BID Addendum No. Five (5)

PROJECT: Iona Preparatory School
Addition and Alterations to the
Pail Verni Fine Arts Center
255 Wilmot Road
New Rochelle, NY 10804

ADDENDUM NO. Five (5)
Initiation Date: June 24, 2021

Architect's Project No.: 1618
PGA Contact: Danny Lam
dlam@petergisolfiassociates.com
914-478-3677 x 340

Scale	Job No.	Date	Drawing No.
NTS	20-2723	04/03/2019	M-403
Drawn

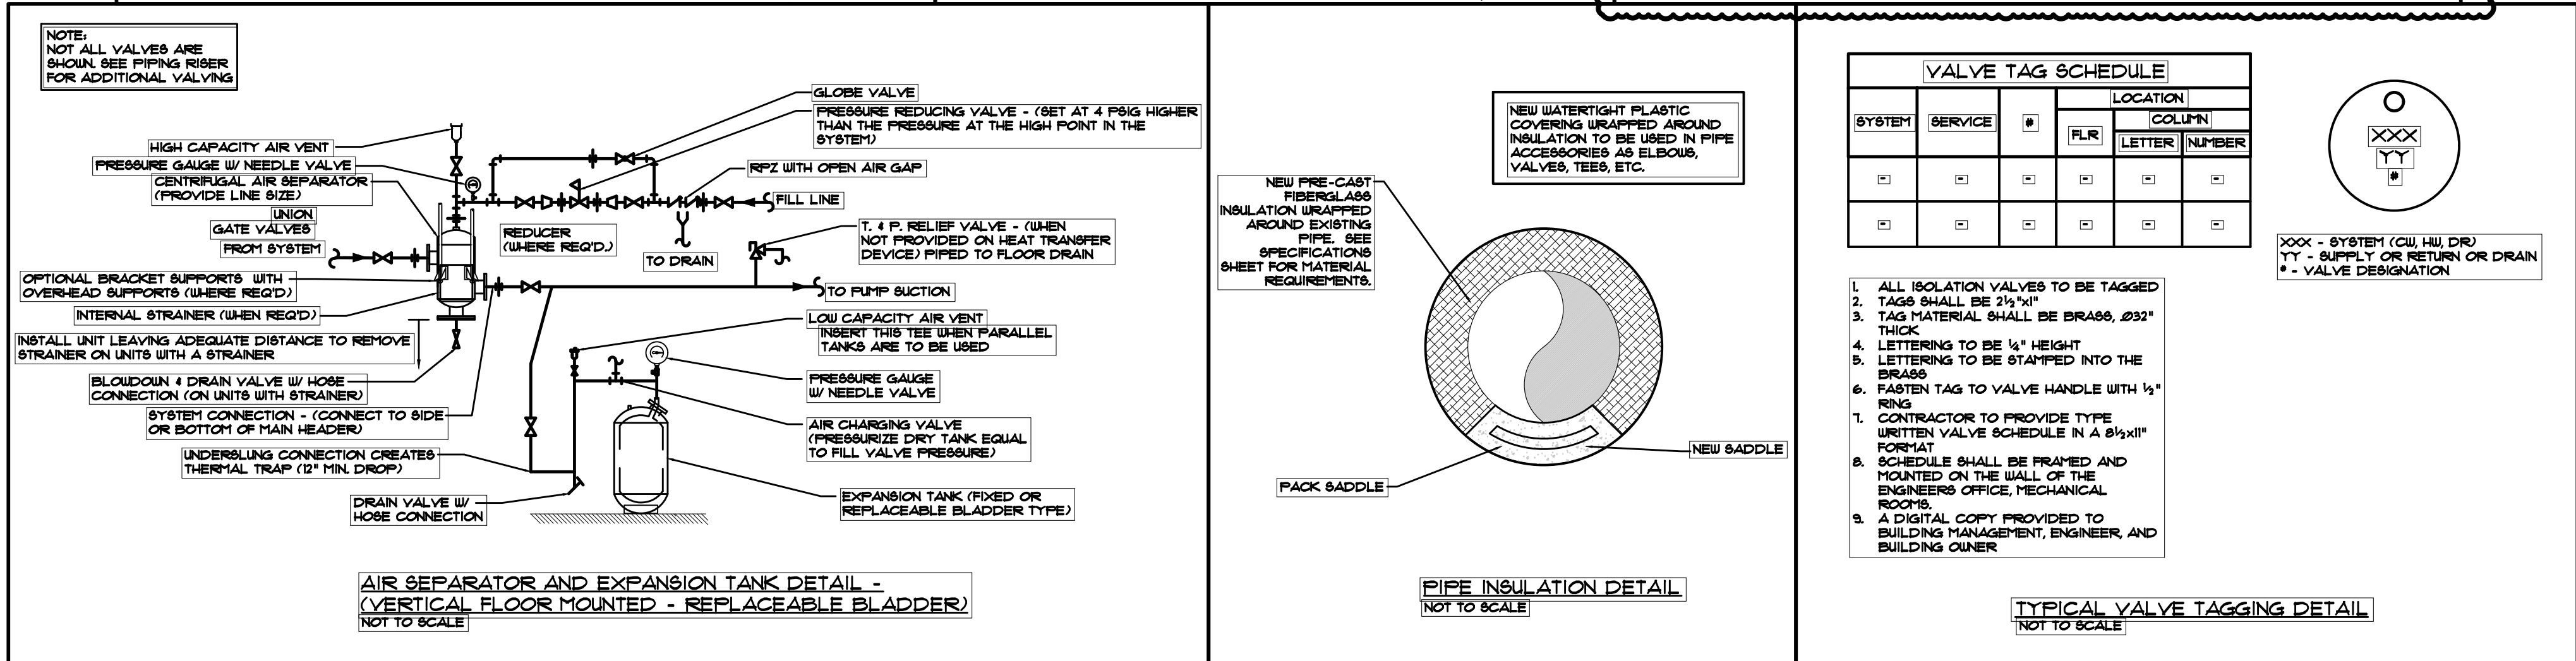
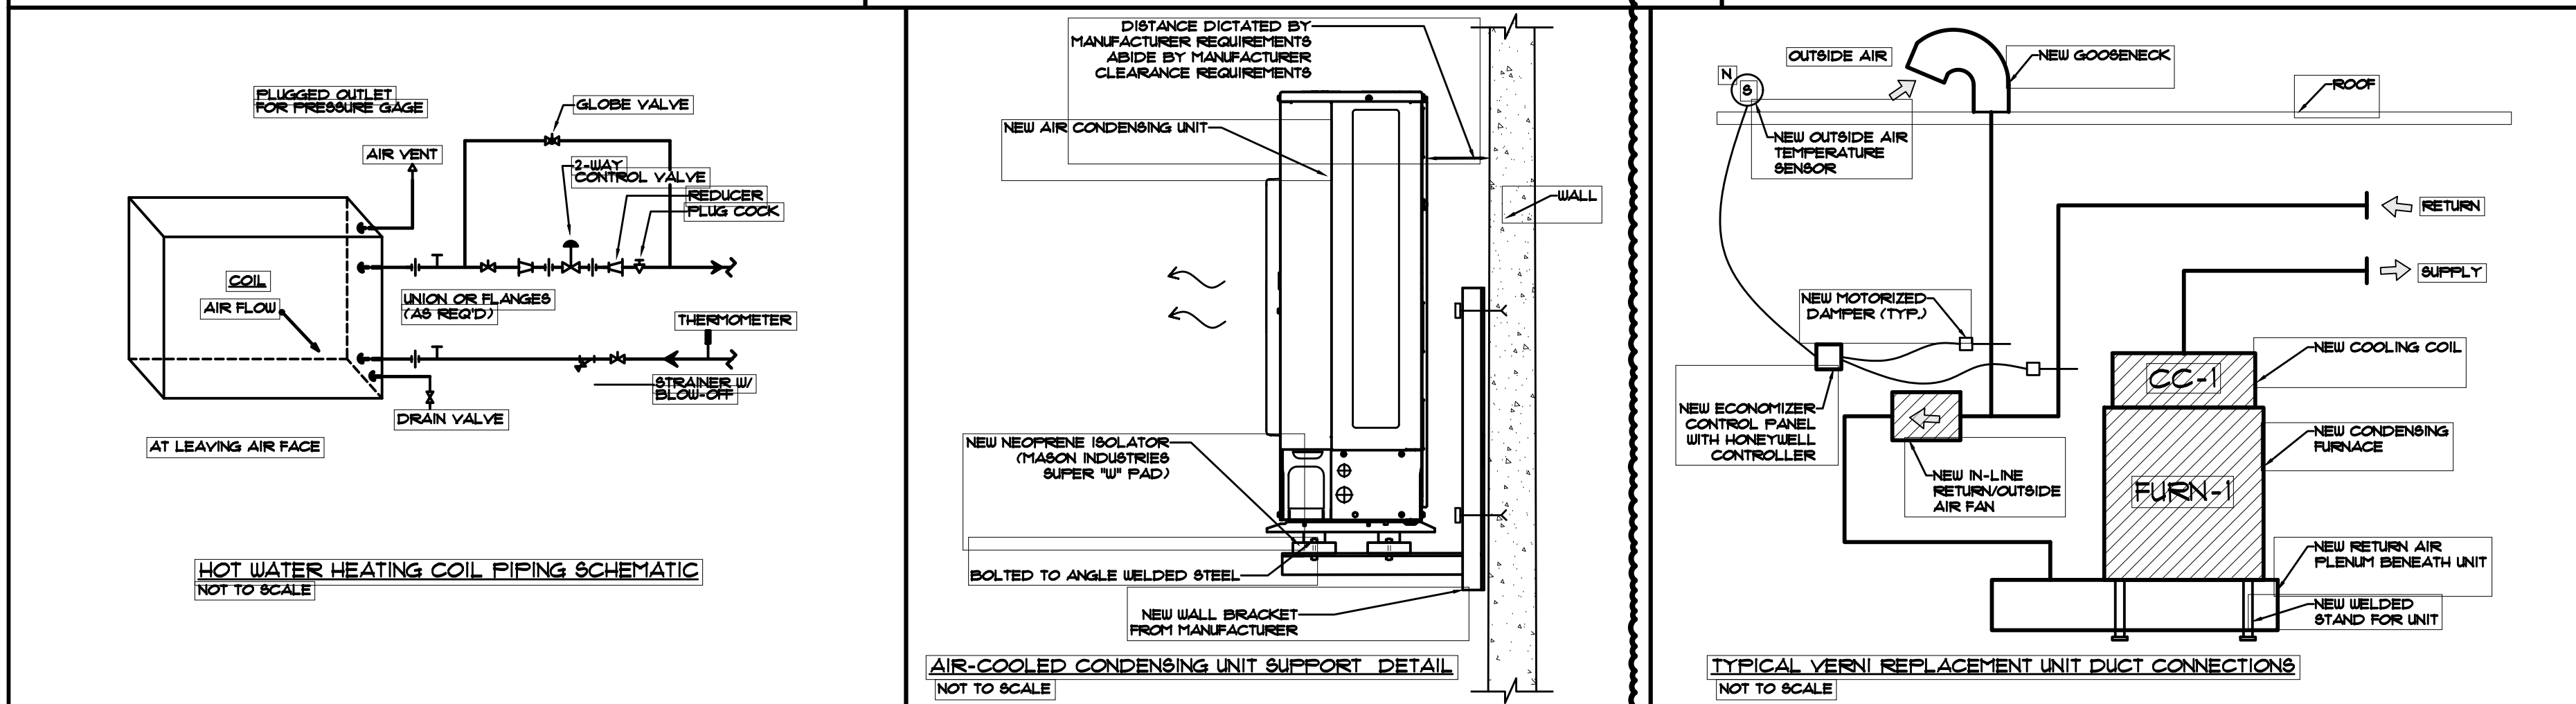
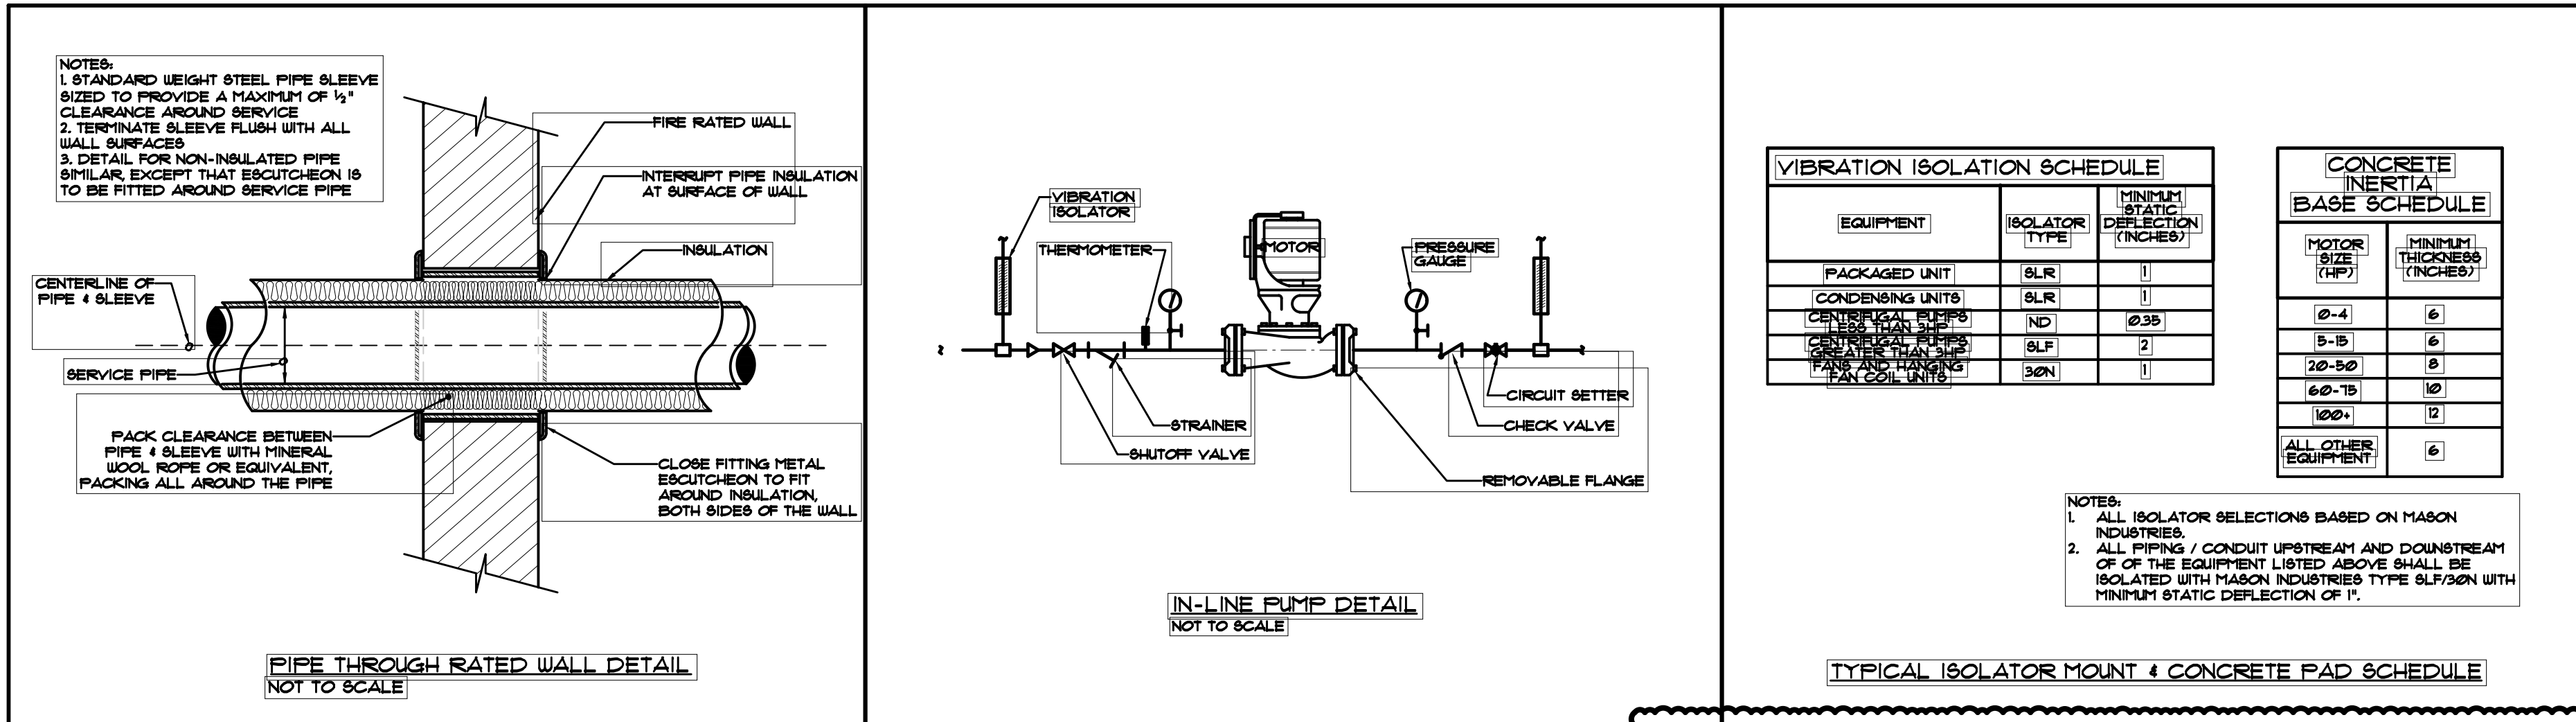
9. See attached revised sheet M-403 with revisions to details.
10. See attached revised sheet M-501 with revisions to mechanical hot water riser diagram.

Drawing No.
E-201

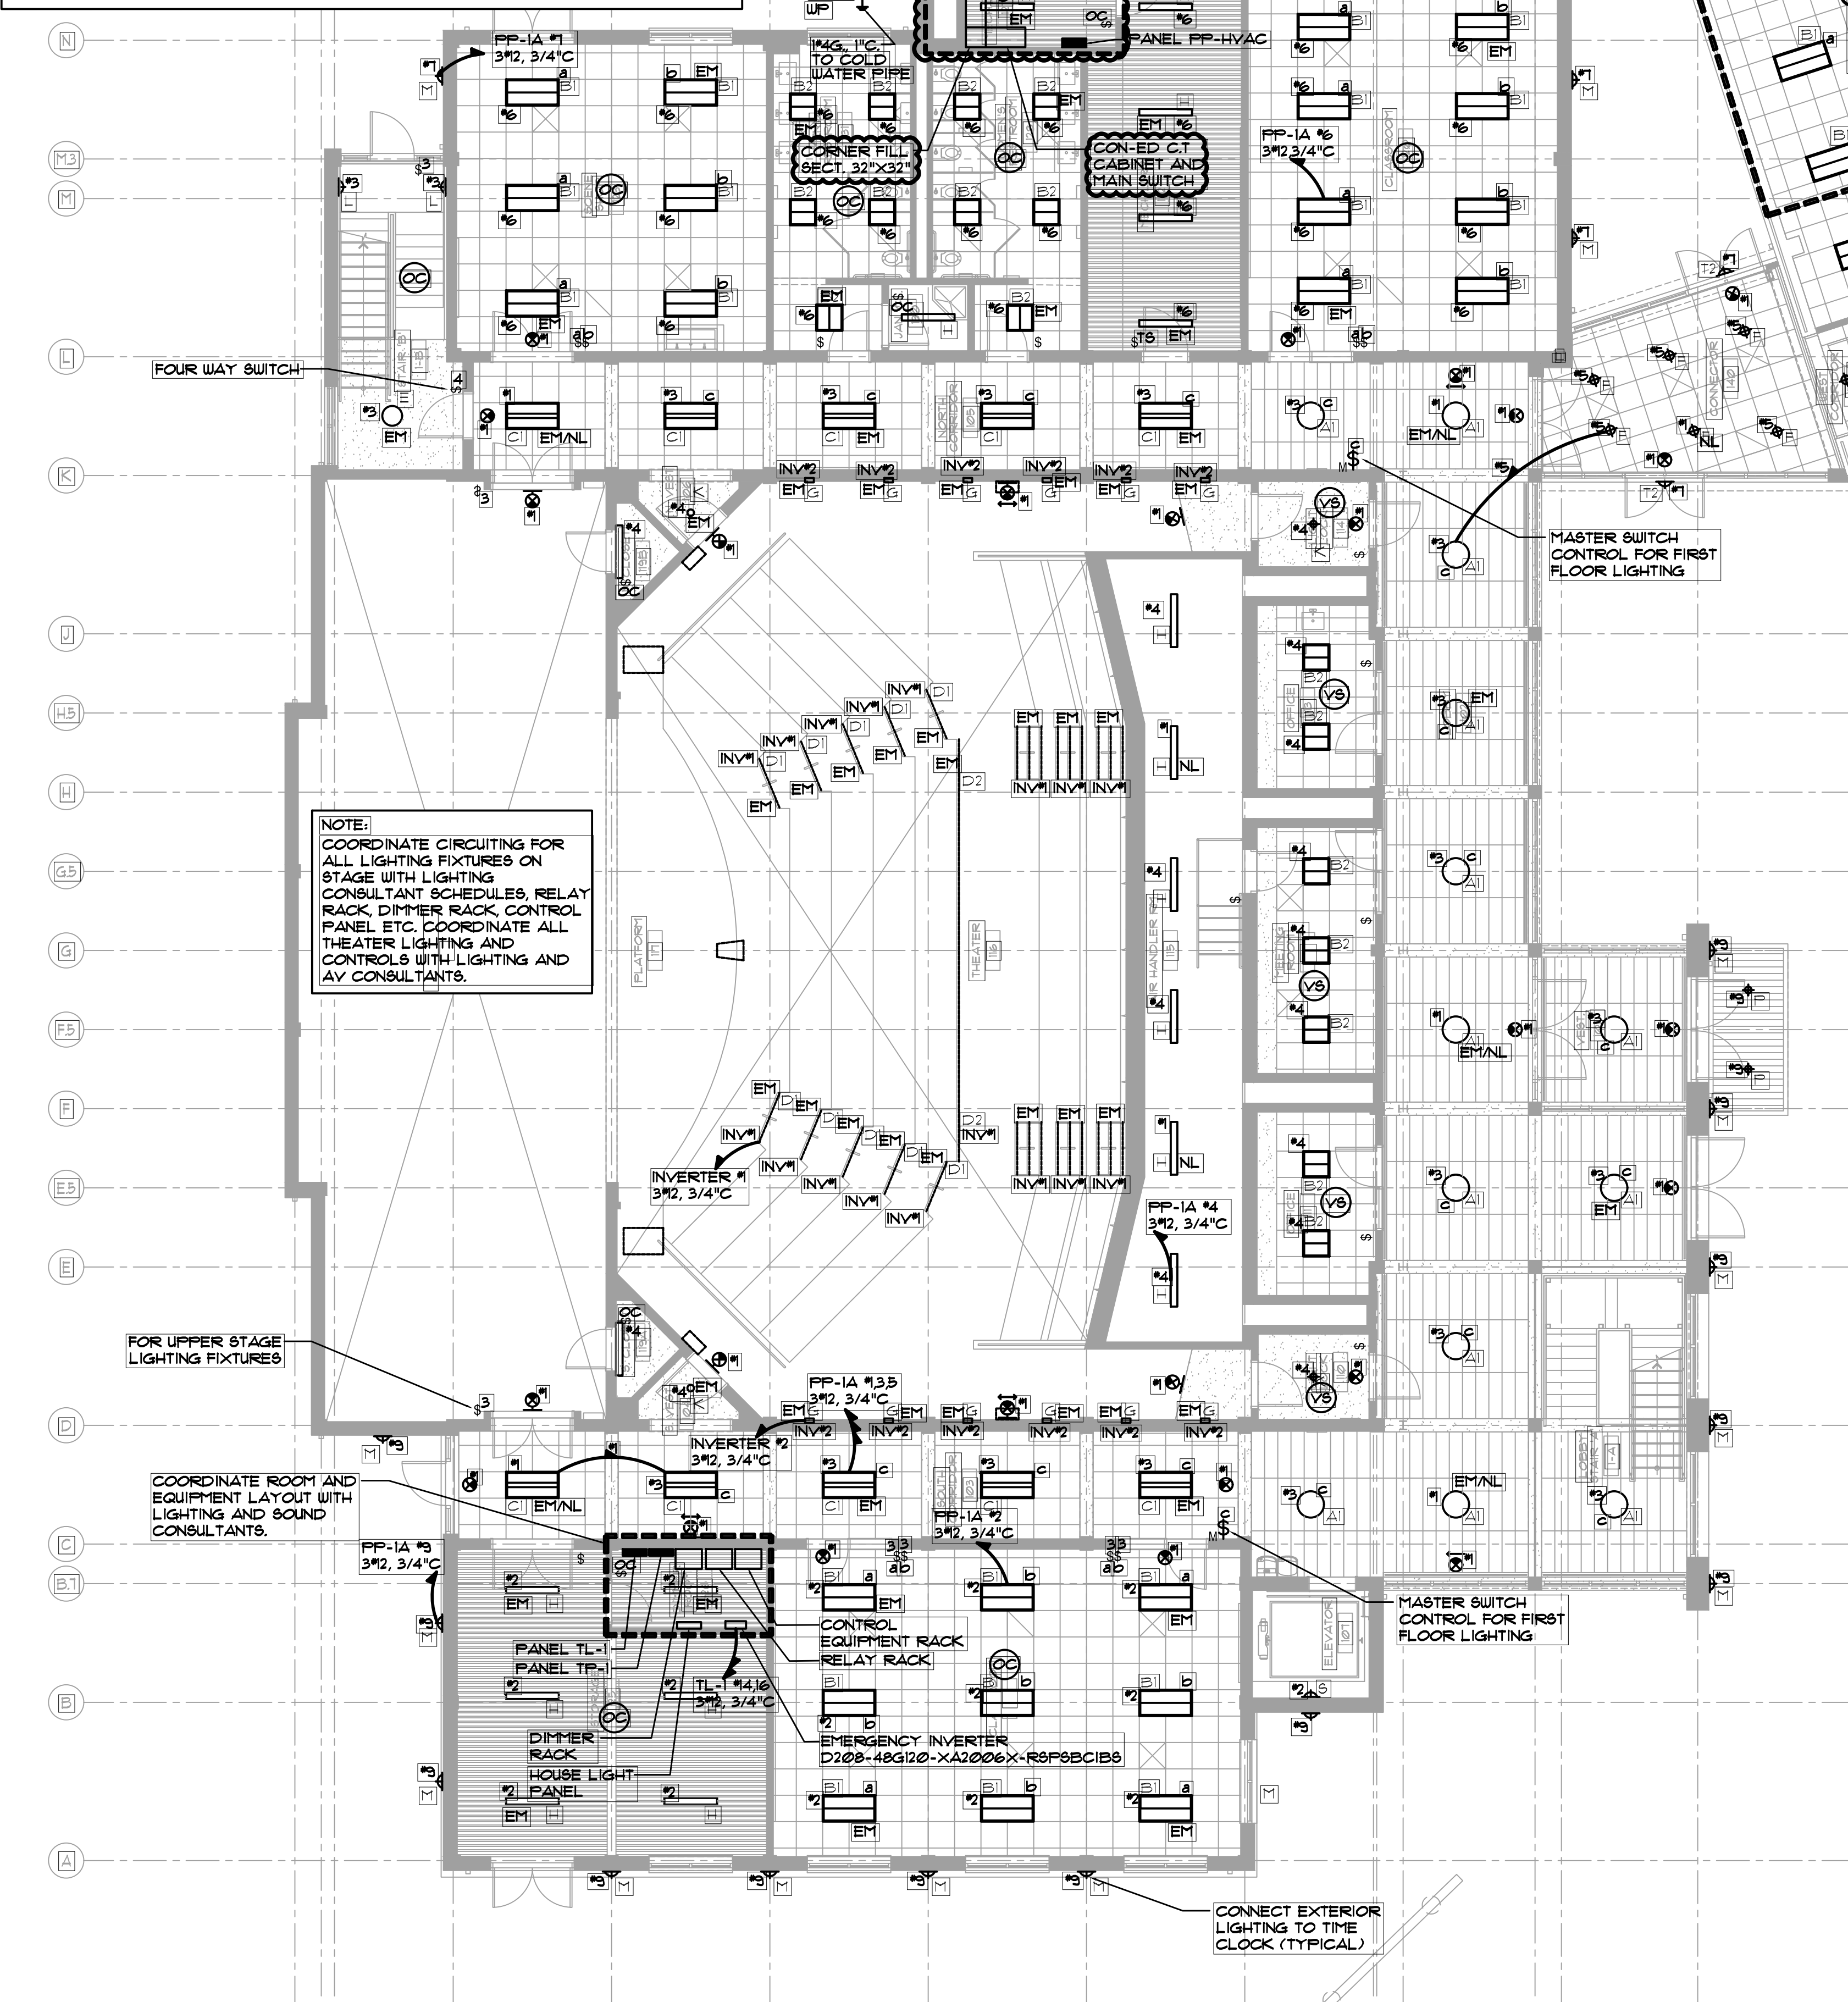
2. See attached revised sheet E-105 with revisions to notes regarding Parent's Hall.
3. See attached revised sheet E-201 with revisions to Verni demolition.
